555 Maple Sports Fields

RFI Response

RFI No.

R-1

LIGHT POLE FOUNDATION DETAIL

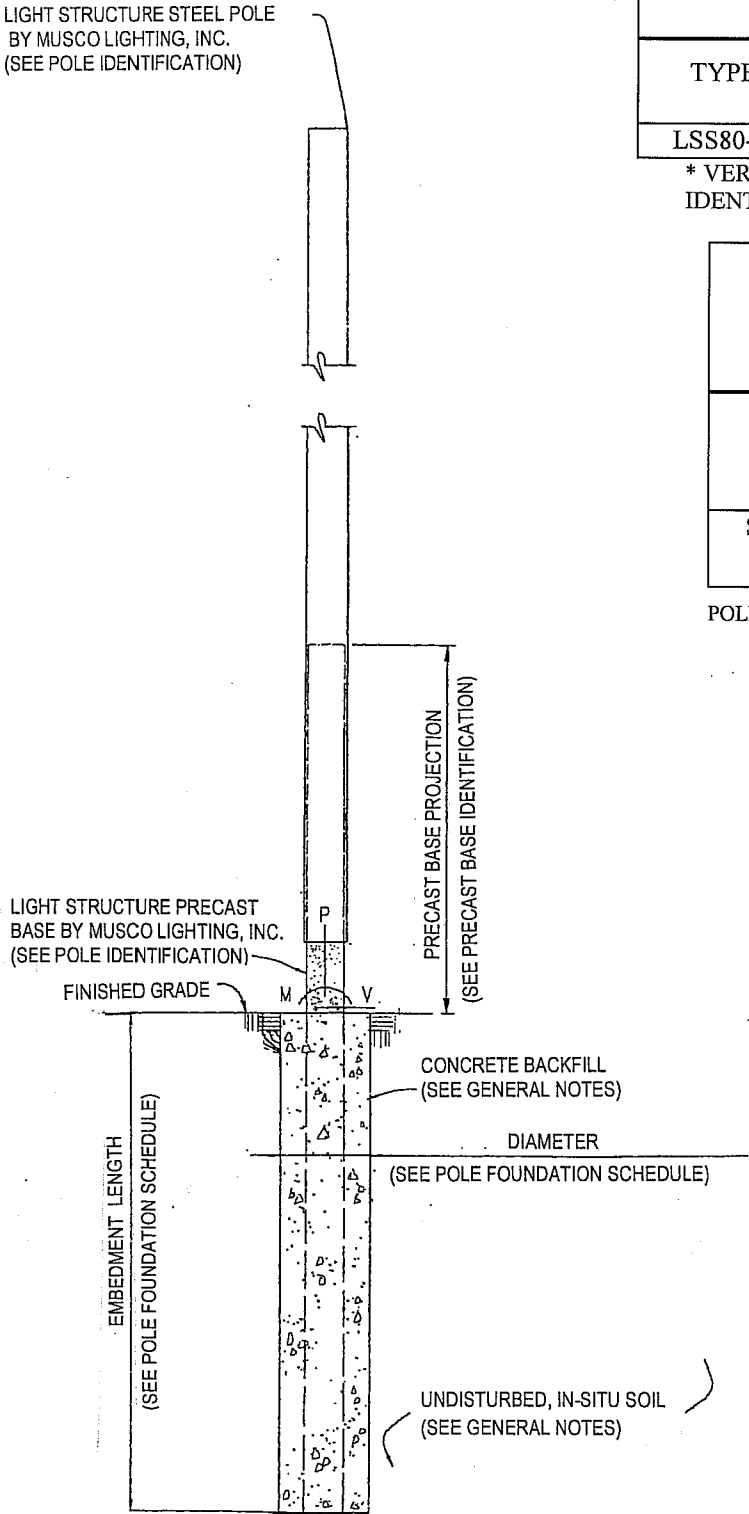
What is the caisson/footing detail for the Musco lights?

What is the caisson/footing detail for the Musco lights?

See Bulletin 2.

44 **SEWER CLEANOUT DETAIL**
NOT TO SCALE

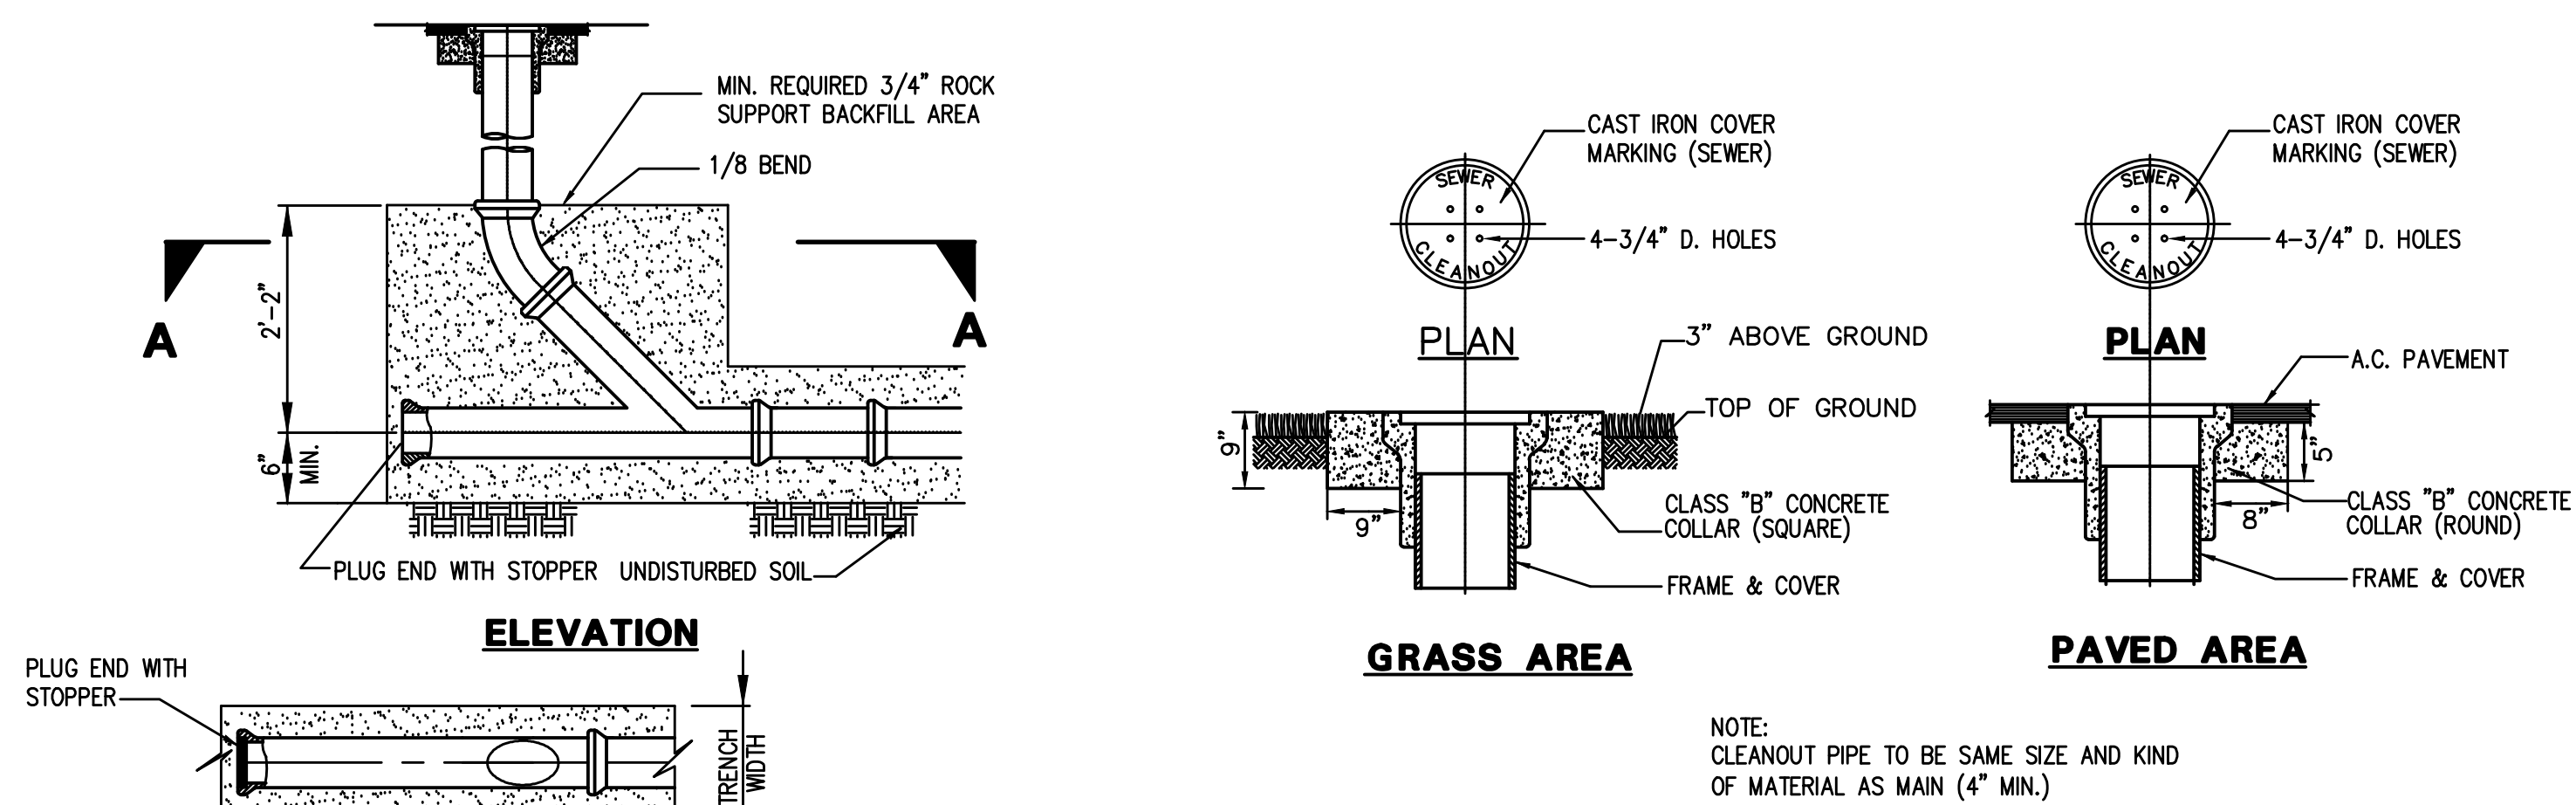
Sheets C-PG2 and CD-5, note 44, indicate to construct a 4" sewer cleanout per City of Torrance Standards. Please provide the City of Torrance Standard Plan, including any necessary details, to construct a 4" sewer cleanout.

Please refer to the attached/revised sheet CD-5 which clarifies the sewer clean-out details.
